Access Compliance Report

Public Rights-of-Way

(Pedestrian Signals)

Intersection ID: N/A	Main Street:	Cross Street: N/A	Location: N/A
ADA ID: 069133BA8A7F	Signal Type: Two Push Buttons-Non APS	Overall Compliance: No	Severity Score: BTN 1:N/A BTN 2: N/A No BTN: N/A
Codes/Mitigation Info/Possible Solution		Field Measurements/Component Compliance

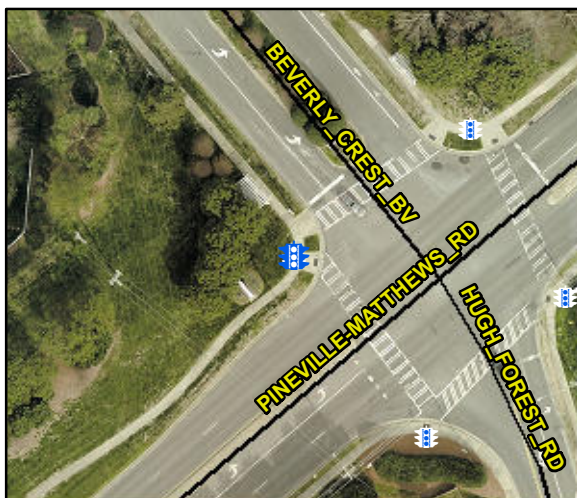
PROW/ADA: TMUTCD 4e.08, R404.2, R404.3, R406.2

Compliance	Description	Data	Compliance	Description	Data
	Button Count	Button2	N/A	Distant to Additional Button (in)	N/A
	Additional Button Present?	No		Additional Button ID	N/A
N/A	Signal Buttons Required?	N/A	N/A	Additional Ped Posts Required	N/A
	How Many Ped Street Xings?	2		Located In An Island/Median?	No
N/A	B 1 Sign Present?	Yes	N/A	B 2 Sign Present?	Yes
Yes	B 1 Sign Purpose?	Yes	Yes	B 2 Sign Purpose?	Yes
Yes	B 1 Sign Lettering & Contrast?	Yes	Yes	B 2 Sign Lettering & Contrast?	Yes
Yes	B 1 Parallel To XWalk?	Yes	Yes	B 2 Parallel To XWalk?	Yes
Yes	B 1 PAR to Button?	Yes	Yes	B 2 PAR to Button?	Yes
Yes	B 1 PAR to XWalk?	Yes	Yes	B 2 PAR to XWalk?	Yes
Yes	B 1 Clear Floor Space?	Yes	Yes	B 2 Clear Floor Space?	Yes
N/A	B 1 FWD Approach?	No	N/A	B 2 FWD Approach?	Yes
N/A	B 1 FWD Approach Constrained?	No	N/A	B 2 FWD Approach Constrained?	No
N/A	B 1 FWD Approach Reach (in)	12.0	No	B 2 FWD Approach Reach (in)	8.0

N/A	B 1 FWD Approach Width (in)	N/A	N/A	B 2 FWD Approach Width (in)	N/A
N/A	B 1 FWD Approach Obstruction?	Yes	N/A	B 2 FWD Approach Obstruction?	Yes
N/A	B 1 FWD Approach Obstruction Dist (in)	4.0	N/A	B 2 FWD Approach ObstructionDist (in)	3.0
N/A	B 1 PARA Approach?	Yes	N/A	B 2 PARA Approach?	Yes
N/A	B 1 PARA Approach Constrained?	No	N/A	B 2 PARA Approach Constrained?	No
Yes	B 1 PARA Approach Reach (in)	8.0	Yes	B 2 PARA Approach Reach (in)	8.0
N/A	B 1 PARA Approach Width (in)	N/A	N/A	B 2 PARA Approach Width (in)	N/A
N/A	B 1 PARA Approach Obstruction?	Yes	N/A	B 2 PARA Approach Obstruction?	Yes
N/A	B 1 PARA Approach Obstruction Dist (in)	4.0	N/A	B 2 PARA Approach ObstructionDist (in)	4.0
No	B 1 Clear Floor Space Slope (%)	4.6	Yes	B 2 Clear Floor Space Slope (%)	4.3
No	B 1 Clear Floor Space XSlope (%)	5.8	No	B 2 Clear Floor Space XSlope (%)	2.6
N/A	B 1 PAR Slope (%)	2.3	N/A	B 2 PAR Slope (%)	7.4
Yes	B 1 Height (in)	35.0	Yes	B 2 Height (in)	35.0

Yes	B 1 Clear Xing Direction?	ClearlyMarked	Yes	B 2 Clear Xing Direction?	ClearlyMarked
	B 1 Crossing Direction	To NE		B 2 Crossing Direction	To SE
Yes	B 1 DistanceTo XWalk (in)	12.0	Yes	B 2 DistanceTo XWalk (in)	0.0
No	B 1 DistanceTo Curb (in)	180.0	No	B 2 DistanceTo Curb (in)	180.0
Yes	B 1 Diameter (in)	2.0	Yes	B 2 Diameter (in)	2.0

Possible Solutions: Replace Signal Push Button With APS Button on New Post. Remove & Relocate Sign.
